TECHNICAL INFORMATION

61055

- Subject** ▶ Change of Ball Bearing 6201DDW
- For Models** ▶ HM1100, HM1100C, HM1130, HM1130C, HM1140C
- Country** ▶ All countries
- Description** ▶ Material of Ball Retainer in Ball Bearing 6201DDW has been changed from sheet steel to nylon in order to enhance its durability.

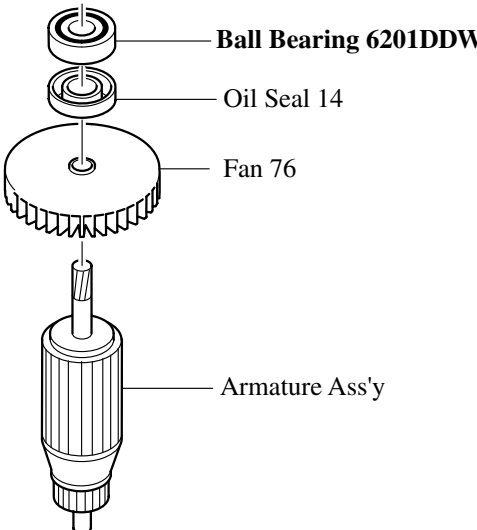
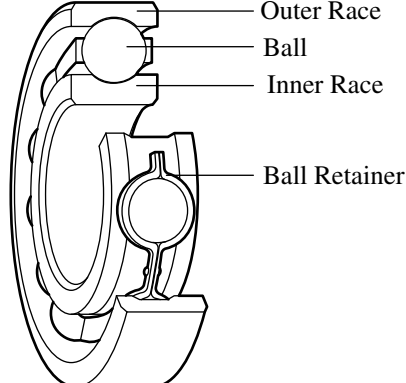
Ball Bearing 6201DDW 		
		▶ Current	▶ New
	Part No.	211129-9	211143-5
	Material of Ball Retainer	Sheet steel	Nylon

Item No.	Current part		Q'ty	I/C	New part		Q'ty	Note
HM1100 :059 HM1100C:059 HM1130 :060 HM1130C:060 HM1140C:046	Ball Bearing 6201DDW 211129-9		1	←	Ball Bearing 6201DDW 211143-5		1

HM1100 : From serial No. 8560E (June, 2000)
 HM1100C: From serial No. 31191E (May, 2000)
 HM1130 : From your order received by us in/after June, 2000
 HM1130C: From your order received by us in/after June, 2000
 HM1140C: From your order received by us in/after June, 2000
